Response to Comment #541 on D2.0

Contribution to IEEE 802.3cy

Ragnar Jonsson - Marvell

December 6, 2022

From wienckowski_3cy_01a_D3d0_work_items

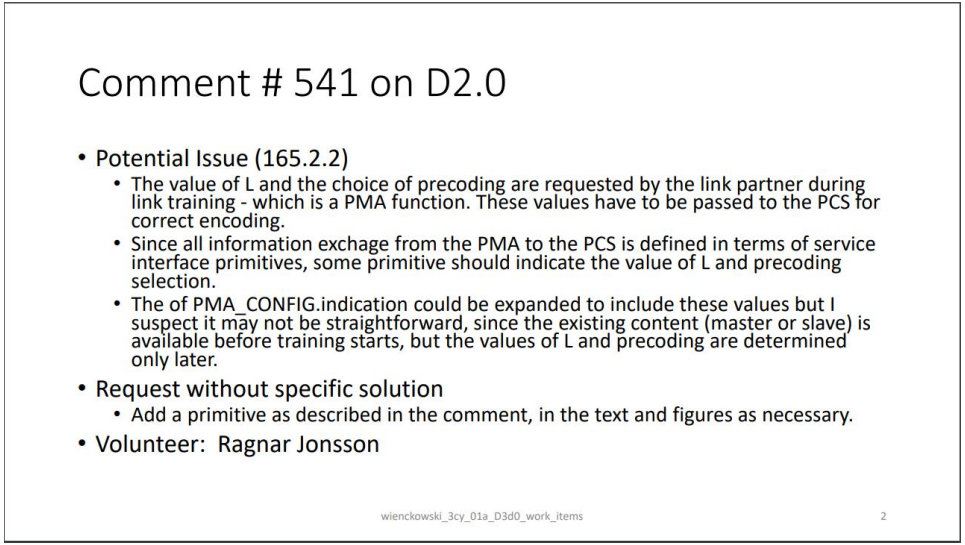
- Work items for P802.3cy D3.0 are captured in the document wienckowski_3cy_01a_D3d0_work_items
- This presentation provides feedback on comment #541 on D2.0
- The comment states that "*The value of L and the choice of precoding are requested by the link partner during link training - which is a PMA function. These values have to be passed to the PCS for correct encoding.*"
- Our assessment is that current draft correctly handles "value of L and the choice of precoding", and that **no update is needed to the draft related to this comment**

- The comment is based on the assumption that passing L value and precoding selection is a PMA function, which is not correct
- The L value and precoding selection is passed in the Infofield, which is decoded by the PCS
- The L value and precoding selection is used internally in the PCS, and there is no need to communicate these values to the PMA

- For additional details on the L value and precoder selection see
  - 165.3.2.2.15 RS-FEC superframe and round-robin interleaving
  - 165.3.2.2.20 Selectable precoder
